# Process Sheet

Part No: D3517-1 PAR #: N/A Fault Category: Prod / ~~fine~~assy med ~~small~~ NCR: Yes No DQA: D Date: 09/03/26  
 Resolution: Scrap Disposition: Scrap QA: N/C Closed: D Date: 09/03/26

Drawing Name: BASKET (A119) STRUT

**From:** Jason Murdoch [mailto:jmurdoch@dartaero.com]  
**Sent:** March 10, 2009 9:52 AM  
**To:** 'Marc Bellavance'  
**Cc:** 'Mike Petsche'; 'L Lacelle'  
**Subject:** NCR on D3517 B46280

DESIGN	DRAWN BY	DART AEROSPACE LTD HAWKESBURY, ONTARIO, CANADA	
CHECKED	APPROVED	DRAWING NO. D3517	REV. A SHEET 1 OF 1
DATE 06.06.07		TITLE BASKET (A119) STRUT	SCALE 1:2
A	06.06.07	NEW ISSUE

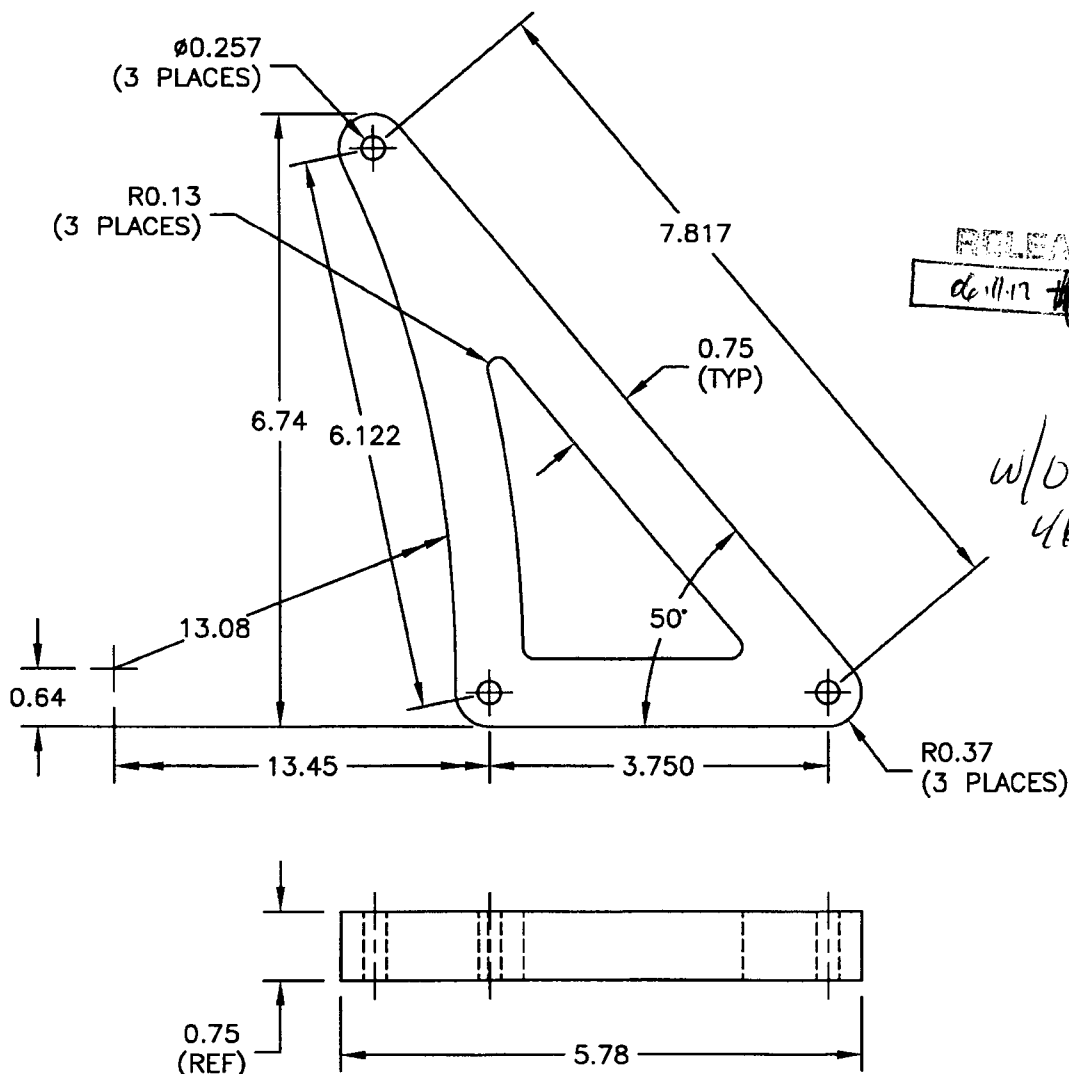
NCR: 46280		WORK ORDER NON-CONFORMANCE (NCR)						
DATE	STEP	Description of NC Section A	Corrective Action Section B			Verification Section C	Approval Chief Eng	Approval QC Inspector
			Initial Chief Eng	Action Description Chief Eng	Sign & Date			
090312	20	All 10 parts are scrap. Ø0.257 is at max Ø0.270 due to the hole taper from the water jet. Thick mat'l  R.C: Program/process.  P.S: This is a duplicate Q.C. lost the original W/O, but kept the e-mail 	 090312	reduce the hole size on the program, to have the holes opened to size manually. scrap; destroy qty 10 & replace.	 090818	 09/08/18	 09/08/18	 090312

The holes in the D3517-1 Strut must be  $\varnothing 0.257'' +0.006''/-0.001''$ .

Since the Strut will be subjected to a considerable load, hole elongation might become a factor on an installation point of view.

Therefore, it is not acceptable to have holes larger than  $\varnothing 0.263''$ , maximum allowable for a close fit on the bolts.

As for inserting a bushing, although I like the idea, the method is not acceptable as it will create problems on a paperwork point of view and it would not be a cost effective solution as the following documents will be affected: create DSI to amend IIN and ICA, record deviation on W/O, update MDL and DR...

The 0.257 holes were oversized to 0.270" OD. This is because the material is too thick, and it oversized on the taper. Any chance that these could be acceptable?

Or even drill open the hole and insert a 6061 tube bushing to bring them back to nominal....just an idea  
Qty 10 parts affected.

I recommend that we scrap the parts. It would be great if the holes could be pierced on the waterjet to a greater tapered diameter that would be smaller than  $\varnothing 0.257''$ .

The holes could then be opened up to  $\varnothing 0.257'' +0.006''/-0.001''$ . Hope it makes sense.
